RAI 03.07.02-24, Supplement 2**QUESTION:****Follow-up Question to RAI 03.07.02-15 (STP-NRC-100036)**

UHS Basin and RSW Pump House:

SUPPLEMENTAL RESPONSE:

UHS Basin and RSW Pump House (Part 1a):

Figure 03.07.02-24.48: Comparison of Z - Direction Raw Response Spectra for Original Mesh Node 16544, Full Basin Upper Bound Soil - PH Roof - 5% Damping

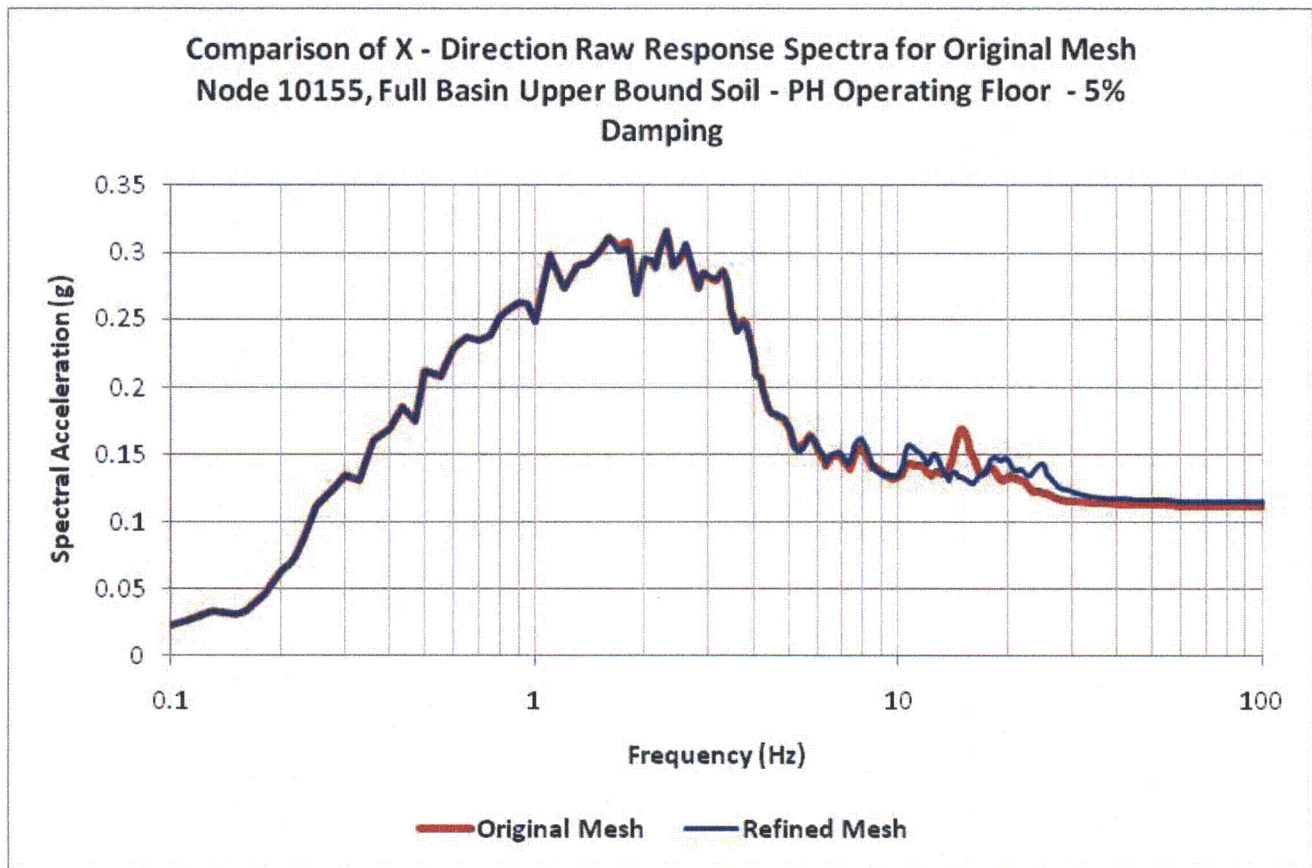
- Vertical direction spectra at the center of the Pump House Roof (see Figures 03.07.02-24.48 and 03.07.02-24.99)
- Vertical direction spectra at the center of the Pump House Operating Floor (see Figure 03.07.02-24.54)
- Vertical direction spectra of the Cooling Tower Walls (see Figures 03.07.02-24.69 and 03.07.02-24.120)
- Out-of-plane horizontal spectra of the UHS Basin Walls (see Figures 03.07.02-24.65 and 03.07.02-24.116)

Based on the above, modifications are warranted for the existing UHS/RSW Pump House response spectra for the above 4 cases.
